**FEMA Levee Certification
Ventura County, California**

**Arroyo Santa Rosa Floodwall (ASR-2)
At East Las Posas Road**

Evaluation Report
February 13, 2009

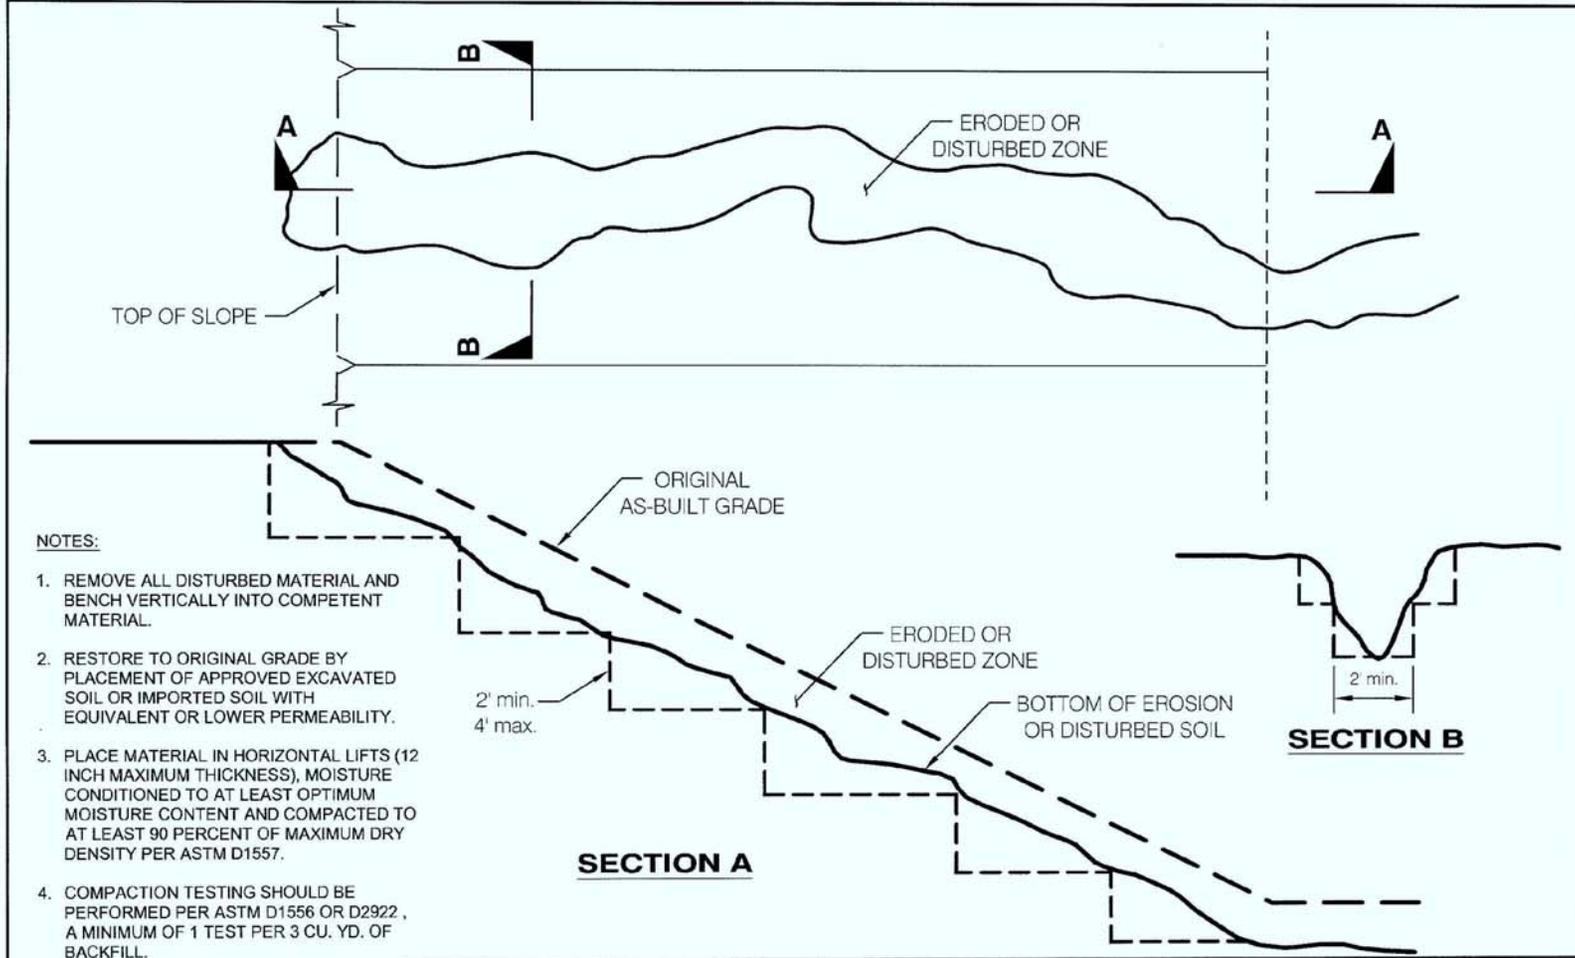
<p>4. Can Tetra Tech provide specs for compaction and grading requirements? Discuss major and minor repair examples.</p>	<p>Compaction requirements are detailed on the attached Figures 1 and 2. Major repair examples include any erosion feature that is deeper than 1 foot or that is greater than 2 feet wide. Major and minor animal burrows are discussed in item 1.</p>
<p>5. Can in-kind materials be used for backfill?</p>	<p>In-kind backfill would be materials free of organic or deleterious debris that has similar or lower permeability than the levee material. These materials could consist of excavated soil, imported soil, concrete, or slurry, and shall be evaluated by the testing and materials lab.</p>
<p>6. Discuss documentation/inspection requirements for verification of grading.</p>	<p>The requirements for verification of grading are discussed above.</p>

1. REMOVE ALL DISTURBED MATERIAL AND BENCH VERTICALLY INTO COMPETENT MATERIAL.
2. RESTORE TO ORIGINAL GRADE BY PLACEMENT OF APPROVED EXCAVATED SOIL OR IMPORTED SOIL WITH EQUIVALENT OR LOWER PERMEABILITY.
3. PLACE MATERIAL IN HORIZONTAL LIFTS (12 INCH MAXIMUM THICKNESS), MOISTURE CONDITIONED TO AT LEAST OPTIMUM MOISTURE CONTENT AND COMPACTED TO AT LEAST 90 PERCENT OF MAXIMUM DRY DENSITY PER ASTM D1557.
4. COMPACTION TESTING SHOULD BE PERFORMED PER ASTM D1556 OR D2922 , A MINIMUM OF 1 TEST PER 3 CU. YD. OF BACKFILL.

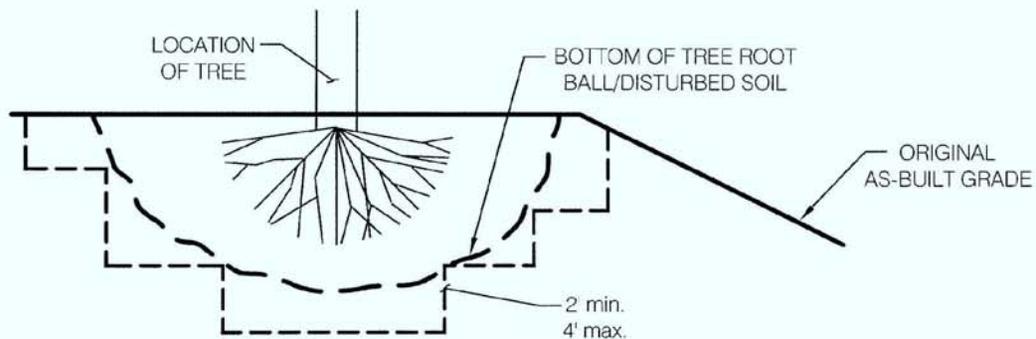
<p>2. Please describe methods for vegetation and rootball removal.</p>	<p>4" DIAMETER TRUNK OR GREATER: Cut the woody vegetation approximately two (2) feet above ground level leaving a prominent stump for use in the rootball extraction process. Remove the stump and rootball by pulling or extracting with a backhoe or similar equipment. Clean the rootball cavity of all loose soil and remaining root system (roots greater than 1/2" diameter). Prepare the cavity by excavating per FIGURE 2. Backfill with excavated soil or imported soil with equivalent or lower permeability. Place material in horizontal lifts no greater than twelve (12) inches. Moisture conditioned to at least optimum moisture content and compacted to at least ninety (90) percent of the maximum dry density of the fill soil per ASTM D1557. Compaction typically requires the use of manually operated compaction equipment or compaction attachment to a backhoe. Compaction testing should be performed per ASTM D1556 or D2922. A minimum of one (1) test per three (3) cubic yards of backfill.</p> <p>2"-4" DIAMETER TRUNK: Cut the woody vegetation stump flush with the ground. Treat the stump with a protective coating similar to polyurethane to prolong the decay process.</p>

1. REMOVE ALL DISTURBED MATERIAL AND BENCH VERTICALLY INTO COMPETENT MATERIAL.
2. RESTORE TO ORIGINAL GRADE BY PLACEMENT OF APPROVED EXCAVATED SOIL OR IMPORTED SOIL WITH EQUIVALENT OR LOWER PERMEABILITY.
3. PLACE MATERIAL IN HORIZONTAL LIFTS (12 INCH MAXIMUM THICKNESS), MOISTURE CONDITIONED TO AT LEAST OPTIMUM MOISTURE CONTENT AND COMPACTED TO AT LEAST 90 PERCENT OF MAXIMUM DRY DENSITY PER ASTM D1557.
4. COMPACTION TESTING SHOULD BE PERFORMED PER ASTM D1556 OR D2922, A MINIMUM OF 1 TEST PER 3 CU. YD. OF BACKFILL.
